City of El Paso – City Plan Commission Staff Report

Case No:	SUSU14-00043 Mesquite Trails Unit Eleven
Application Type:	Major Preliminary
CPC Hearing Date:	June 19, 2014
Staff Planner:	Nelson Ortiz, (915) 212-1606, ortiznx@elpasotexas.gov
Location:	East of Joe Battle and South of Vista Del Sol
Acreage:	27.85 acres
Rep District:	6
Existing Use:	Vacant
Existing Zoning:	R-3A (Residential)
Proposed Zoning:	R-3A (Residential)
Nearest Park:	Burning Mesquite Park (.18)
Nearest School:	John Drugan Elementary School (.62 mi.)
Park Fees Required:	Pending park comments
Impact Fee Area:	N/A
Property Owner:	Americas Loop 375 Joint Venture
Applicant:	Americas Loop 375 Joint Venture
Representative:	CEA Group

ATTACHMENT 3

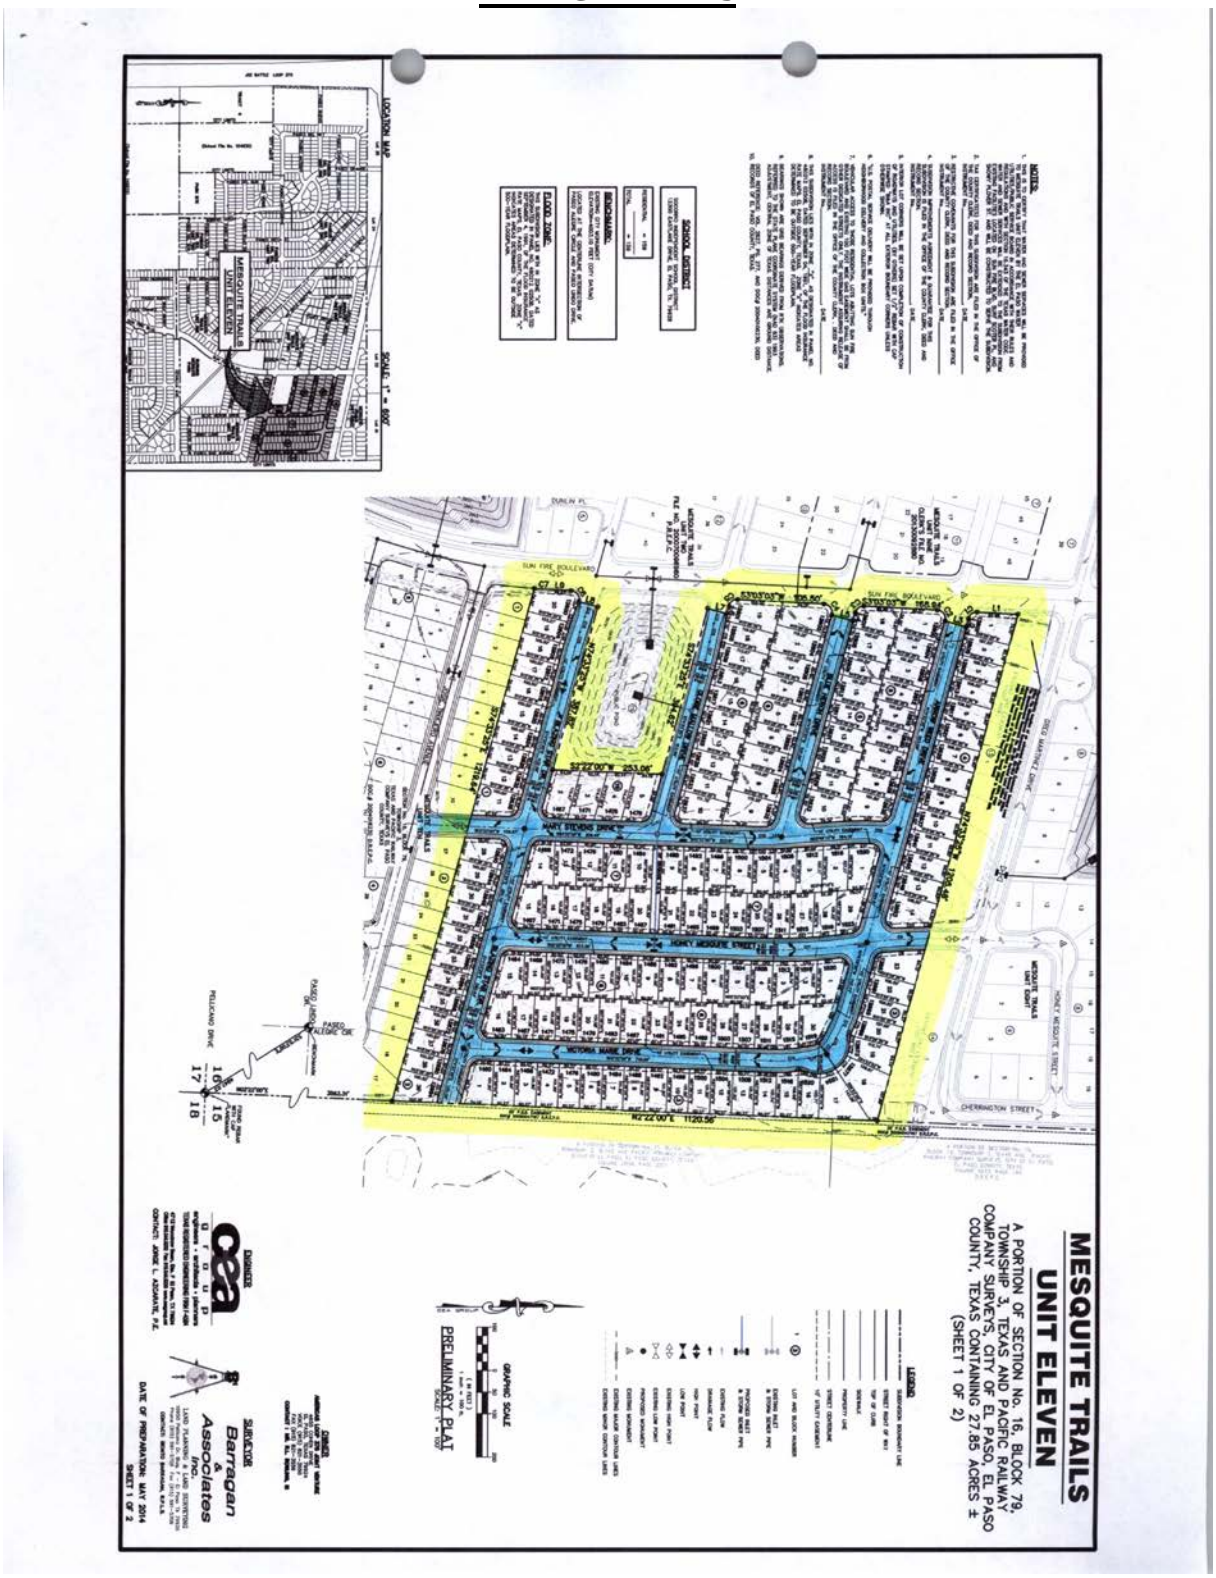
1. Confirm that existing downstream conveyance structures have sufficient capacity to handle the developed runoff from the proposed subdivision. As per the City of El Paso's Drainage Design Manual, the HGL shall remain below the finished grade for the 50-yr. storm frequency.

Please note that this subdivision is composed of **159** (R-3A) Single-family dwelling lots and does not include any parkland dedication with-in this plat, however, applicant previously dedicated and constructed an 11.10-acre Off-site Park (Burning Mesquite Park) as part of the Paseos Del Sol Land Study.

Based on the following calculations, this development meets the minimum "Parkland" requirements and applicant still has a credit balance of **1.47 acres** of "Parkland" or **147 dwelling units** that can be applied towards any subsequent subdivisions with-in the approved Paseos Del Sol Land Study.

2. There is an existing 16-inch diameter water main along Sun Fire Blvd. located approximately 20 feet east of the street center line. No direct service connections are allowed to the water main as per the El Paso Water Utilities – Public Service Board Rules and Regulations.
3. There are existing 8-inch diameter stub-outs from the existing 16-inch diameter main along Sun Fire Blvd. east to Arrow Weed Dr., Blue Heron Dr., Globe Mallow Dr. and Blazing Star Dr.

4. There are existing 12-inch and 8-inch diameter sanitary sewer mains that extends along Sun Fire Blvd. located approximately 14 feet west of the street centerline.
5. There is an existing 8-inch diameter stub-out from the existing 12-inch diameter sanitary sewer main along Sun Fire Blvd. east to Globe Mallow Dr.
6. There is an existing 18-inch diameter stub-out east to Blazing Star. This 18-inch main is to be extended east to connect to the 42-inch sewer interceptor.
7. There is an existing 42-inch diameter sewer interceptor located approximately 5-feet east of the eastern boundary line of the subdivision. No direct service connections are allowed to this sewer main as per the El Paso Water Utilities – Public Service Board Rules and Regulations.

8. Annexation fees are due at the time of new service application for individual water meters within the subject property.
9. An 18-inch diameter sanitary sewer main extension will be necessary from Sun Fire Blvd. along Blazing Star Dr. to the existing 42-inch diameter interceptor to provide service to the subdivision.
10. EPWU requires a new service application to serve the subject property. New service applications are available at 1154 Hawkins, 3rd Floor. The following items are required at the time of application: (1) hard copy of subdivision plat with street names and addresses; (2) finalized set of street improvement plans, including storm sewer; (3) digital copy of subdivision plat; (4) benchmark check; and (5) construction schedule. Service will be provided in accordance with the current EPWU – PSB Rules and Regulations. The owner

3. As per Section 19.16.020.I (Intersections), "streets shall be laid out so as to intersect as nearly as possible at right angles. No intersection shall be less than an included angle of seventy degrees and no more than one hundred ten degrees." Please note that the all proposed intersections shall meet the aforementioned criteria.
